## Physical Layer ARQ: New Proposed Feature for 802.16ab

Document Number: IEEE 802.16abc-01/27  
Date Submitted: 2001-09-03  
Source: Joe Kwak  
Interdigital Communications  
482 Degas  
Bolingbrook, IL 60440  
Voice: +1-630-739-4327  
Fax: +1-630-739-4327  
E-mail: joekwak@mcs.net

Base Document: Working Group Comments on document 802.16ab-01/01r1

Purpose: This presentation presents the concept for the proposed new physical ARQ feature, the benefits of such a feature and the interaction of this feature with other PHY and MAC functions.

# Dual Channel Adaptive Hybrid ARQ Example

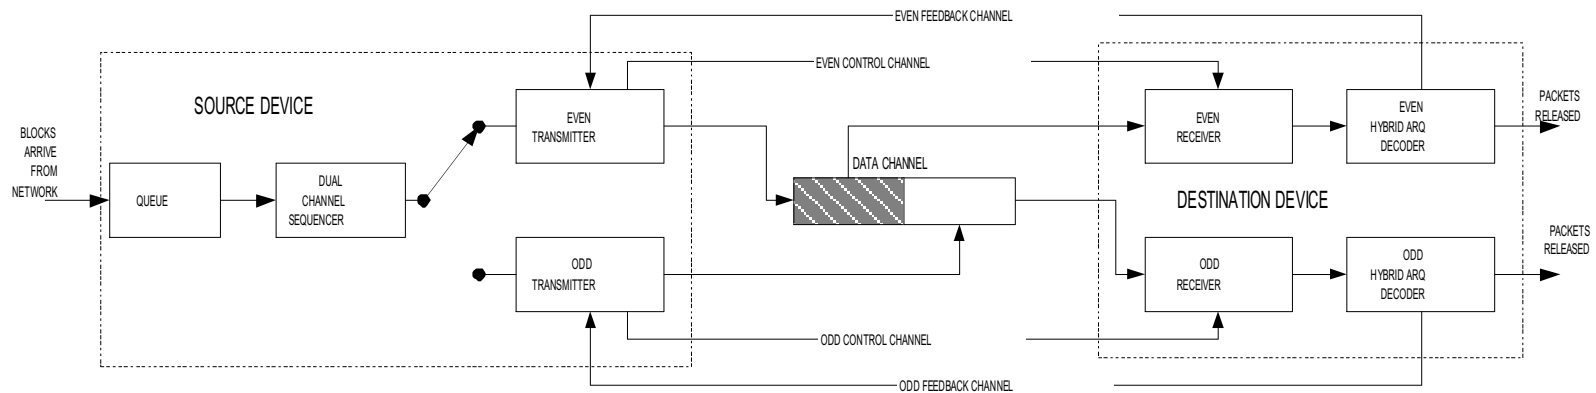
## ∞ Dual Channel Stop-and-Wait ARQ enables Adaptive Hybrid ARQ (HARQ)

- The dual channels avoid stalls normally associated with stop-and-wait by providing a one frame delay to communicate ACKs
- Memory and control overhead costs of HARQ significantly reduced
- Transmit PARQ blocks released within 5 Frames after two retransmissions
- Nmax parameter used to limit number of retransmissions and end-to-end transmission delay

# PARQ SNR Gain Example

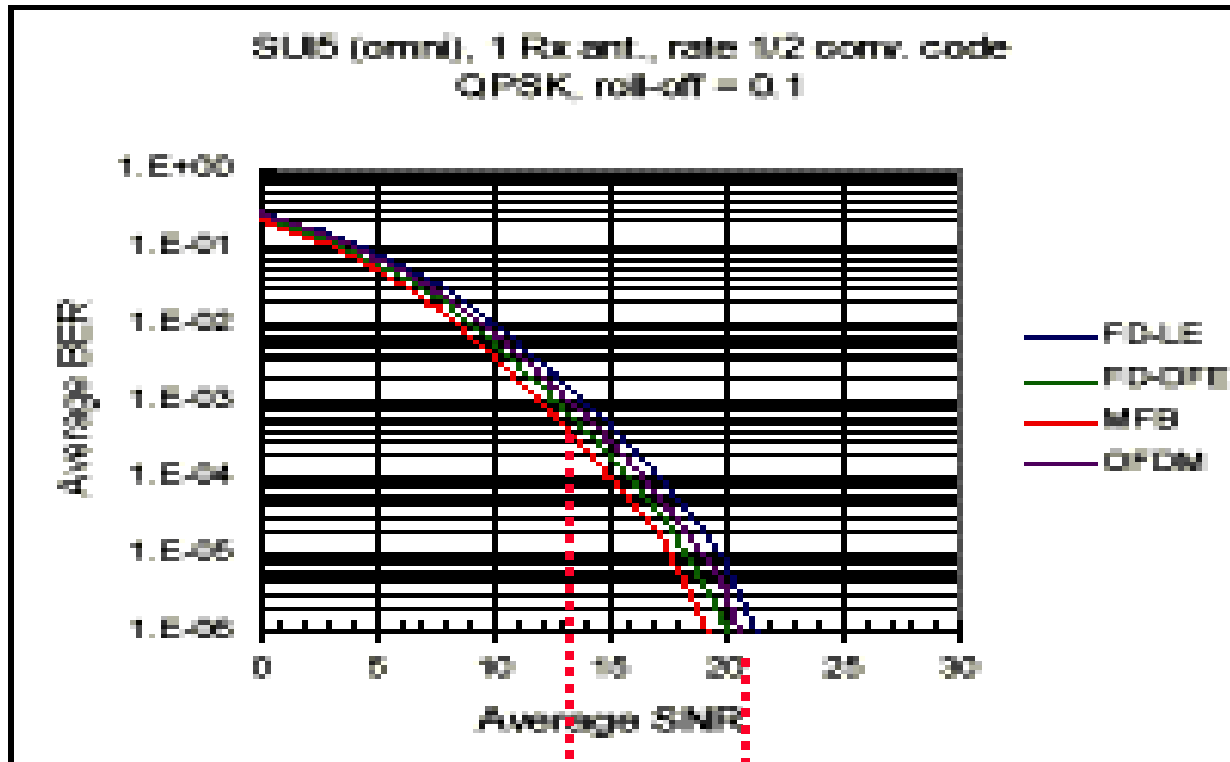
Simulation Results from 802163p-01\_31r2.pdf

Improvement using PHY ARQ = 7 dB

PHY ARQ operating point:  
BER =  $10^{-3}$  (10% BLER, 100  
bit block)

MAC ARQ operating point:  
BER =  $10^{-6}$  (.1% BLER, 1000  
bit block)

## ¥ Proposed approach is a low rate CDMA Uplink channel spread across the entire uplink band:

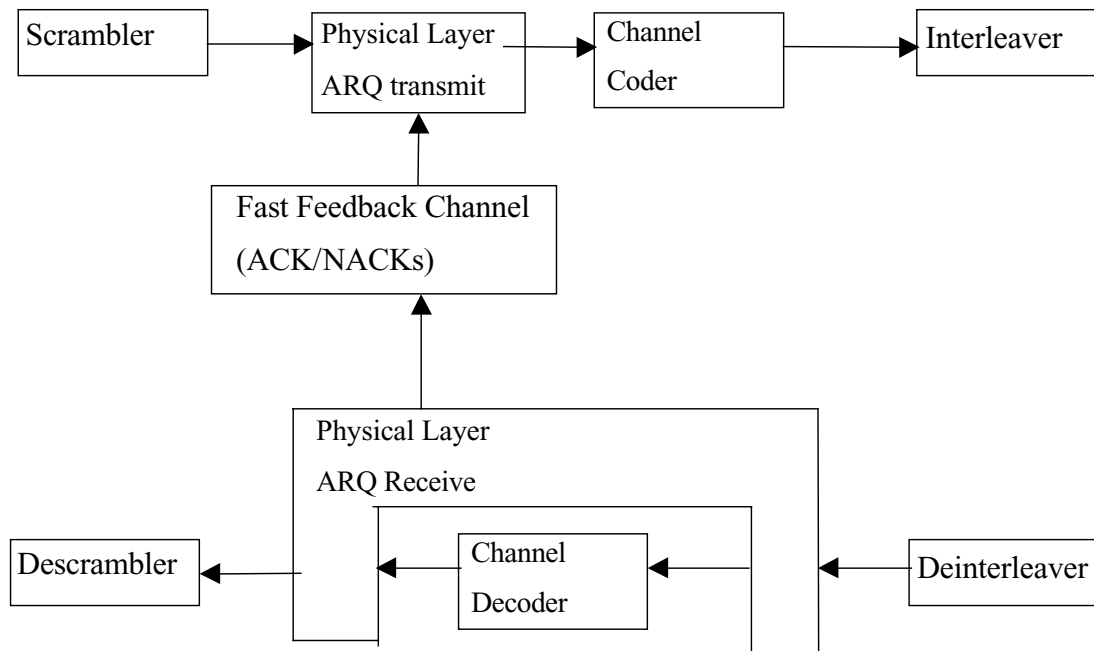
- Will not interfere with (orthogonal to) normal SC or MC Upstream modulations; will add to Upstream interference power level, however.
- Family of CDMA codes can be allocated to SS's and provide source identification to BS.
- FFC rate can be reduced by permitting simultaneous uplink transmissions from different SSs on different codes.
- May reuse CDMA transmitter used in SS for ranging.
